To:	Joseph Dichose / FCC Application Processing Branch
From:	Richard Mullen / Matsushita Electronic Corp. of America
Date:	November 2, 2000
Re:	FCC ID: ACJ96NKX-CC2000
Applicant:	Matsushita Electric Industrial Co., Ltd.
731Confirmation Number:	EA98956
Correspondence Ref. No.:	16894
Correspondence Date:	November 1, 2000
Fty Ref No:	KMTDKM4-00-AK10
Type Product:	900 MHz Remote Control for Play Station

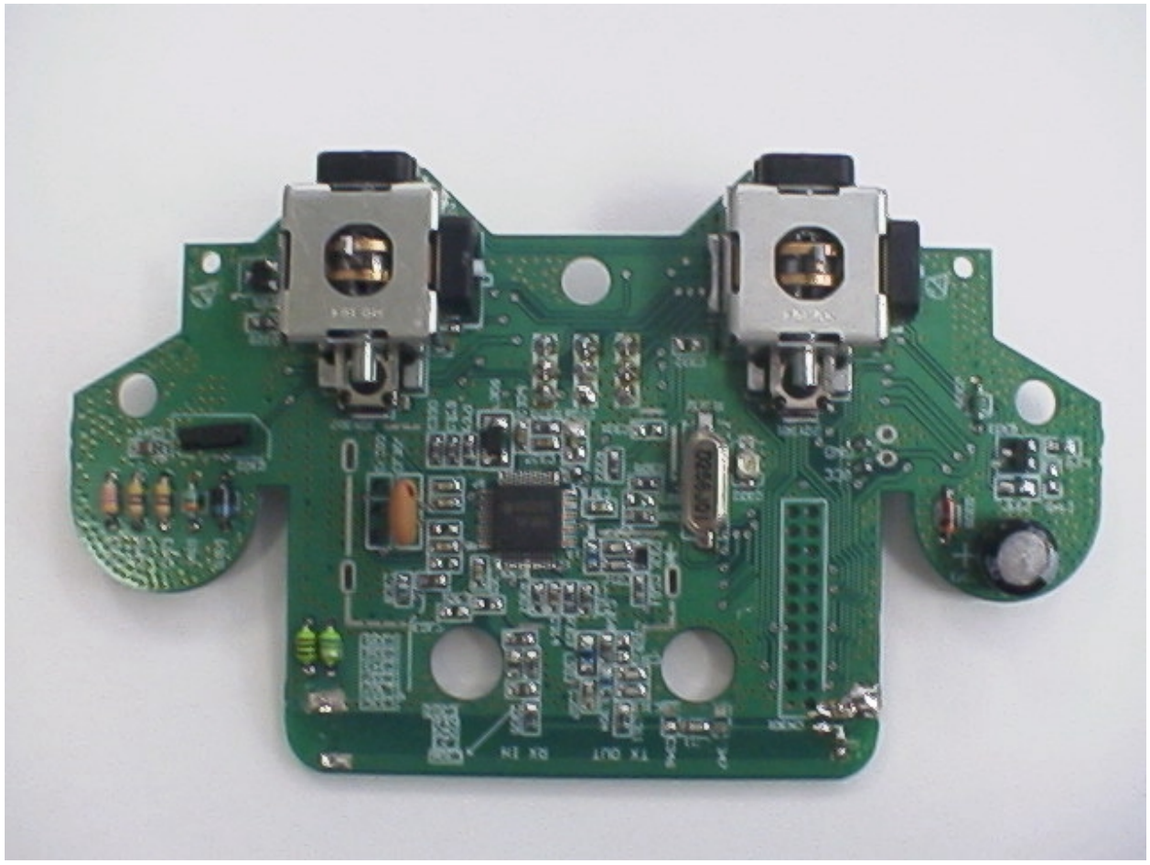
2. The remote control's uses a permanent attached antenna designed of copper tracks on the printed wiring board and thus, is in compliance with Section 15.203 for antenna replacement requirement.
